## RECALL CAMPAIGN BULLETIN

NTB17-088

### VOLUNTARY RECALL CAMPAIGN 2016-2017 TITAN; REAR SEAT BELTS

**CAMPAIGN ID #:** R1719  
**NHTSA #:** 17V-268  
**APPLIED VEHICLES:** 2016-2017 Titan (A61) with Crew Cab  
2016-2017 Titan XD (X61) with Crew Cab

Figure 8

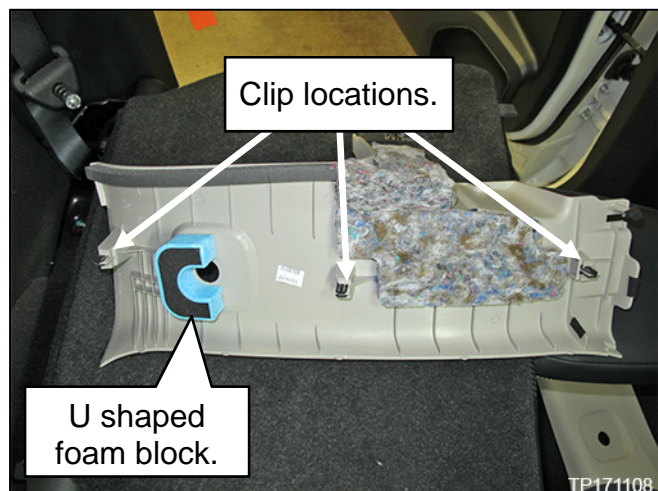
8. Obtain the new rear pillar upper finisher.

**NOTE:** Verify that the **NEW** rear pillar upper finisher is equipped with a U shaped foam block near the D-ring anchor bolt hole.

Figure 13

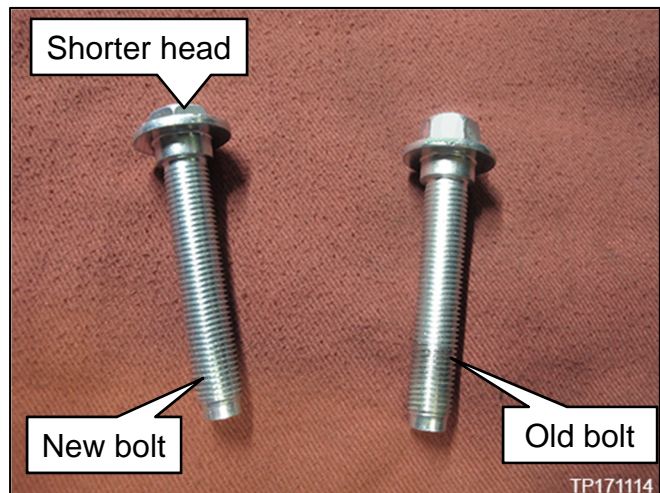
15. Remove the old anchor bolt from the D-ring anchor and install the new one.

- The new bolt is equipped with a shorter head than the old bolt.
- New style anchor bolt is listed in the Parts Information.

Figure 17

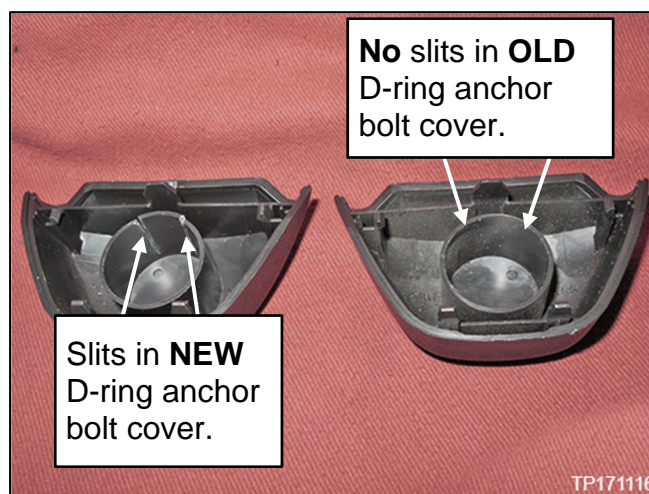
20. Install **new** style D-ring anchor bolt cover.

**NOTE:** Refer to Figure 17 to verify NEW style D-ring anchor bolt cover is being used.
